RESOLUTION NO. 352

A RESOLUTION OF THE CITY OF SHORELINE, WASHINGTON AMENDING THE TRANSPORTATION MASTER PLAN TO RECLASSIFY A COLLECTOR ARTERIAL TO A LOCAL SECONDARY STREET, REVISE A CROSS-SECTION, PROVIDE CLARIFYING NOTES TO THE MASTER STREET PLAN, AND CORRECT SCRIVENER'S ERRORS RELATED TO RIGHT-OF-WAY AND THE STREET CLASSIFICATION MAP

EXHIBIT A – RECOMMENDED CHANGES TO THE TRANSPORTATION MASTER PLAN

Figure A

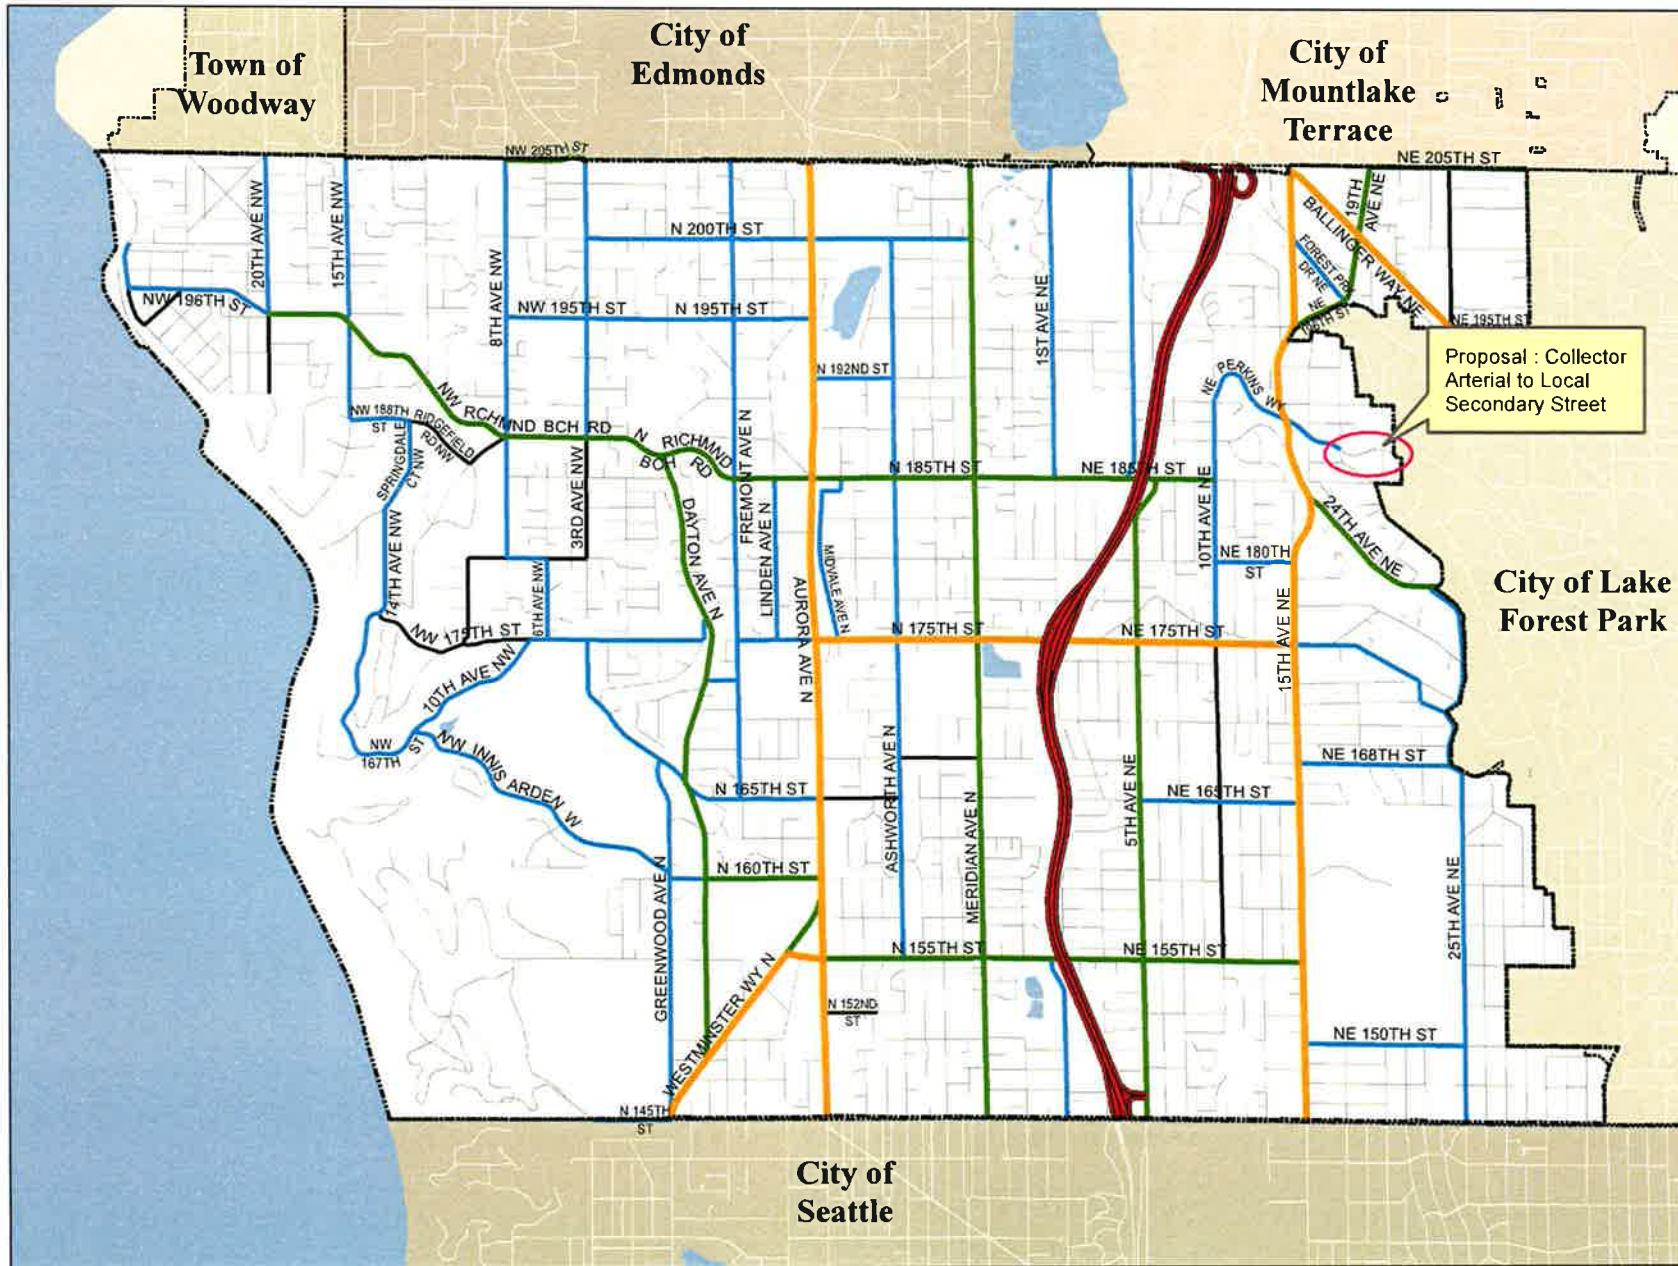
PAGE	SUBJECT	AMENDMENT	NOTES/EXPLANATION
1	Page 29 (Figure A)	Street Classification	<ul style="list-style-type: none"> Change the street classification of NE Perkins Way from 18th Avenue to NE 22nd Avenue NE from Collector Arterial to Local Secondary Street Eliminate language identifying the previous title of Local Primary Street and Local Secondary Street 	<ul style="list-style-type: none"> The Washington State Department of Transportation did not grant approval to classify this roadway segment as a Collector Arterial as desired by the City. This change renders the City's Street Classification Map consistent with their determination. The language identifying the previous title of Local Primary Street and Secondary Street is a remnant from the original draft public review plan. This language should have been removed when the plan was originally adopted in December 2011.
2	Appendix D	Master Street Plan	See below	<ul style="list-style-type: none"> Correcting the right-of-way width for 5th Avenue NE from NE 185th Street to NE 195th Street, as the existing MSP identifies an incorrect requirement. Correcting the notes associated with the roadway segment on 10th Avenue NE from NE 175th Street to NE 185th Street. During the planning for the City's North Fork Thornton Creek Low Impact Development (LID) Stormwater Retrofit Project, staff found that space could be utilized behind the sidewalks on both the east and west sides of the roadway and is recommending removal of the language that specifies this allowance for the west side only. Include the width requirements for sidewalks associated with adjacent land uses on Local Secondary Streets. This requirement is already stated within the text of the TMP. Change the cross-section of the segment of Westminster Way N from Greenwood Avenue N to Fremont Avenue N to match that of the segment from Fremont Avenue N to N 155th Street. Due to the potential redevelopment of Aurora Square as part of the Community Redevelopment Plan, the City should maintain a wider cross-section until such time as the roadway needs can be studied. Correct the termini of NE Perkins Way as a Collector Arterial at 18th Avenue NE in accordance with WSDOT's determination
